# California High-Speed Train Project

RFP No.: HSR 11-16  
Design Variance Report

06/04/2012 ADDENDUM 2 - RFP HSR 11-16

Fresno Station Crossover  
Distance from Station

**Alternative 4 – Box Culvert, Shoring Wall Adjacent to Trench Wall**

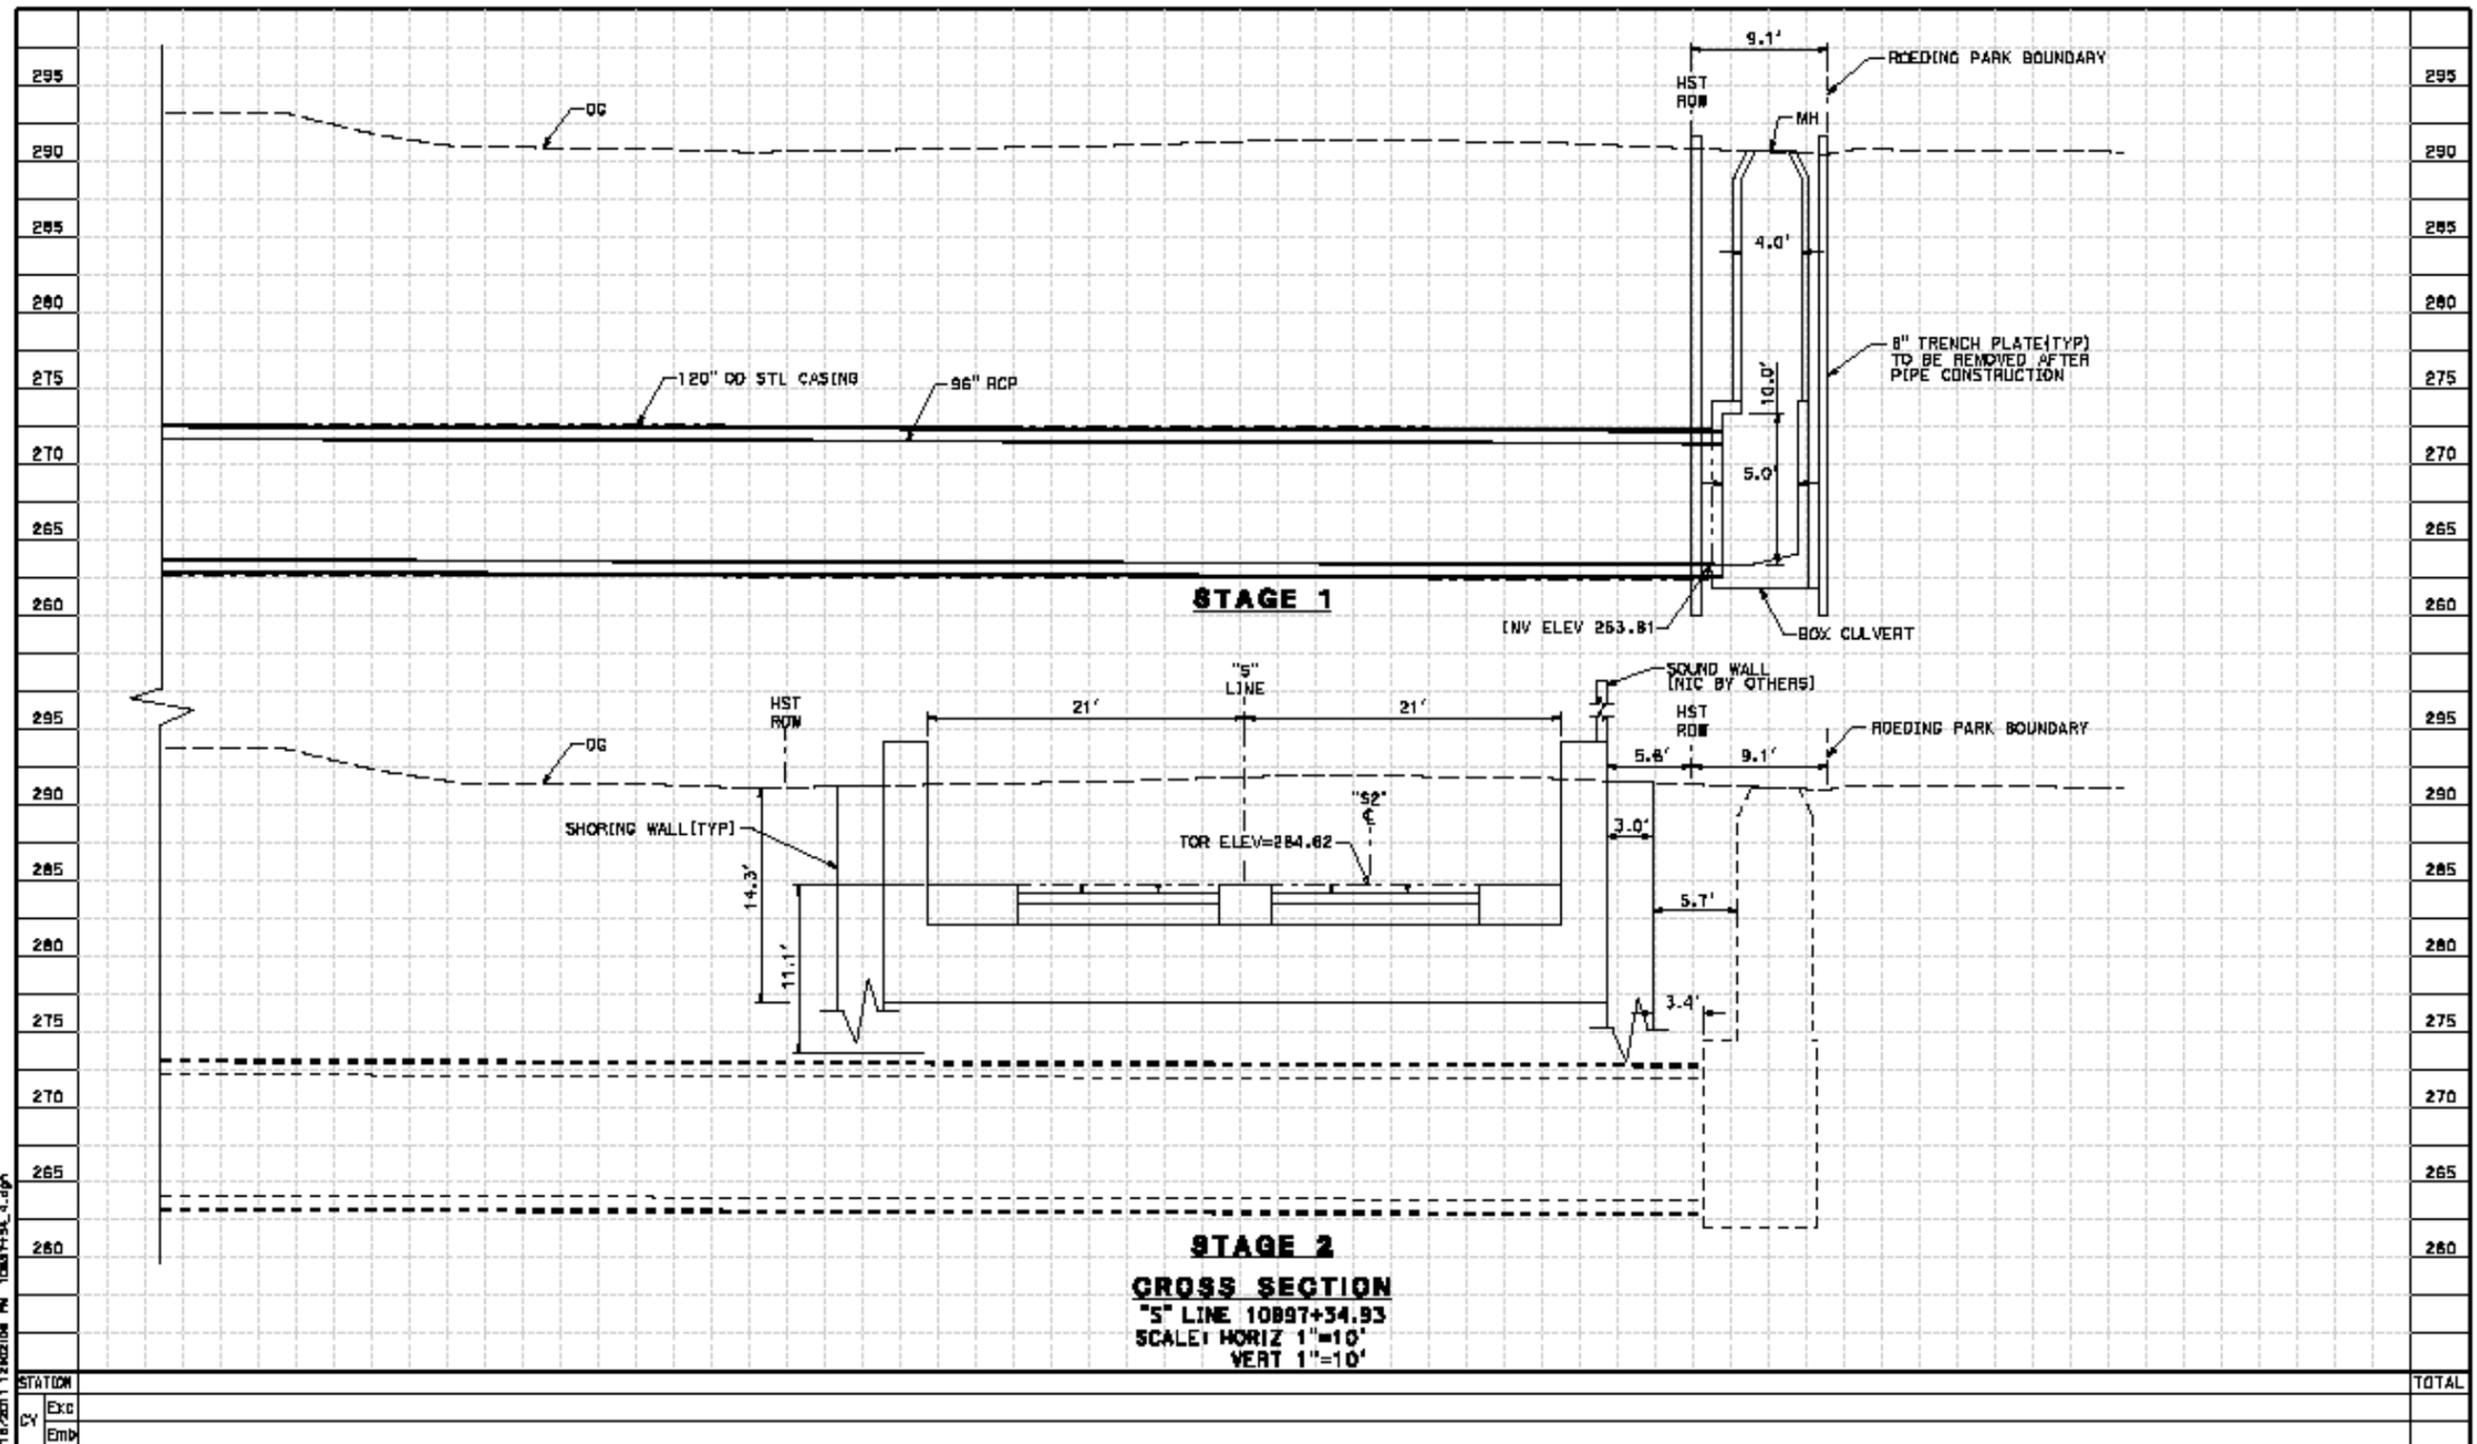
Alternative 4, presented in Attachment D, presents a proposed solution similar to Alternative 3 but replaces the longitudinal section of 96-inch storm drain with a 6'x10' precast concrete box culvert. The box culvert would be constructed longitudinally to the HST alignment using trench plates. Junction boxes could be modified sections of the precast concrete box culvert.

This shoring wall would provide for the future excavation and removal of the 96-inch storm drain without compromising the integrity of the Trench structure.
